DEFENSE NUCLEAR AGENCY
 ARMED FORCES RADIOBIOLOGY RESEARCH INSTITUTE
 BETHESDA, MARYLAND 20014

Reference your letters dated 2 September 1981, (with list of questions) and 18 September 1981, approval of our request for an extension to answer those questions.

AFRRI ANSWERS TO NRC STAFF QUESTIONS CONCERNING
THE AFRRI SAFETY ANALYSIS REPORT (SAR) DATED MAY 12, 1981

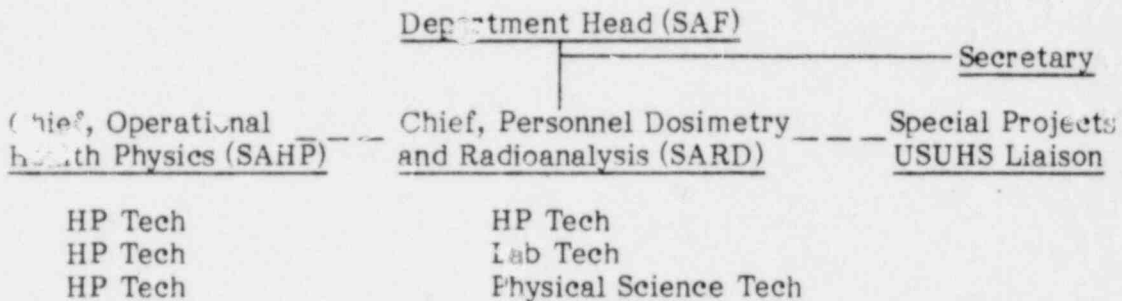
1. DESCRIBE THE RADIATION PROTECTION STAFF. IDENTIFY THE NUMBER, LEVEL, RESPONSIBILITIES OF PERSONNEL, AND THE LINES OF COMMUNICATION.

The following flow diagram describes the Radiation Protection Staff, number, level, and lines of communication.

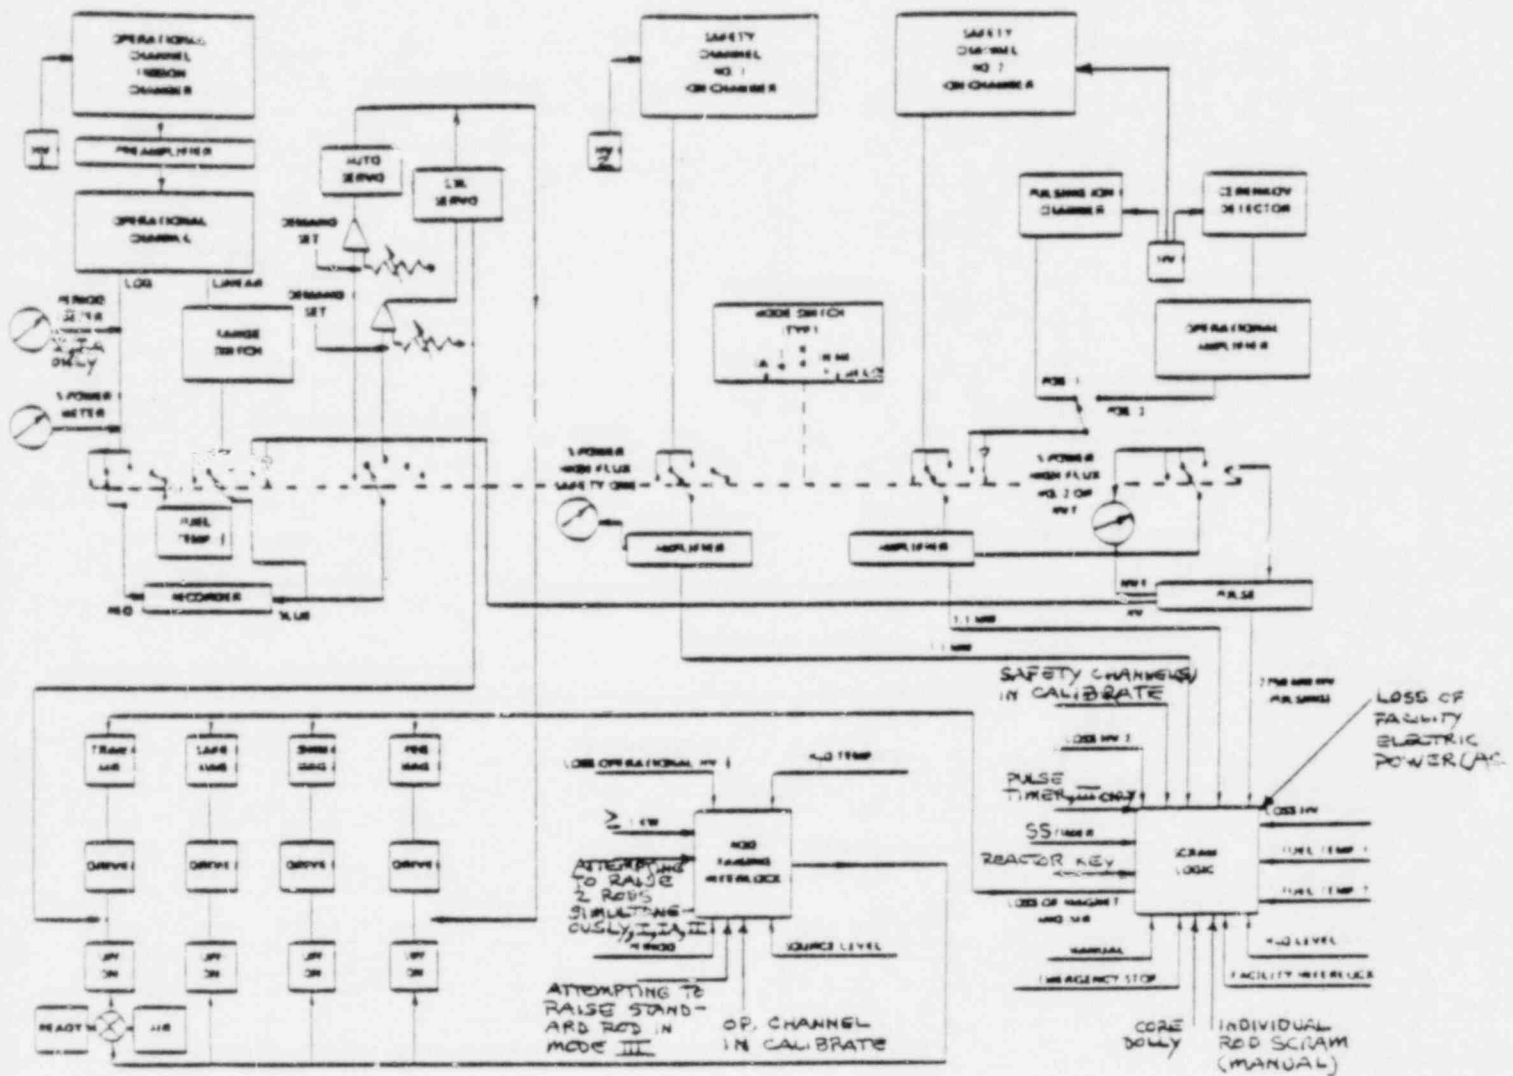
23. HOW MANY USED FUEL ELEMENTS ARE IN THE POOL STORAGE RACKS? WHAT PROBLEMS WILL ARISE IF THE WATER LEVEL DROPS? IF THERE IS A TOTAL LOSS OF COOLANT, HOW WILL THE FUEL ELEMENTS BE MOVED TO REPAIR THE LEAK? INCLUDE THE ESTIMATED EXPOSURES OF OPERATIONS PERSONNEL. (IV-14)

Each fuel element storage rack is composed of two subracks which are welded together in a stepped arrangement with the subracks (each of which can hold six fuel elements) at different but fixed elevations. The upper subrack is fitted with two aluminum tie rods which extend vertically above the pool water surface and clamp securely to the reactor tank wall rim.

With this arrangement, the upper subrack of each fuel element storage rack lies against the inside surface of the reactor tank under approximately nine feet of water while the lower subrack of each fuel element storage rack is approximately 6 inches away from the inside surface of the reactor tank under approximately twelve feet of water.

In the unlikely event that a partial loss of water from the reactor tank should occur such that the storage racks become partially or totally uncovered but the core remains covered, the fuel elements in storage would be lowered beneath the standing water level either individually, using the fuel element handling tool, or collectively by removing the storage racks having fuel elements in them to the bottom of the pool beneath the standing water level. If the drop in pool water level occurred as a result of a leak or breach within the primary water and purification loop, no further in-pool precautionary measures would be required prior to repairing the leak or breach and recovery of the facility. If, however, the drop in pool water level occurred as a result of a leak or breach in the reactor tank wall, the core and spare fuel elements would be moved into the pool water volume opposite the breach and the lead shield doors would be closed to provide the maximum amount of water and lead shielding between the breach point and the fuel. Recovery operations in either of these two cases would involve only slight occupational exposures most likely on the order of 10-50 mrem but certainly less than 100 mrem to any single individual.
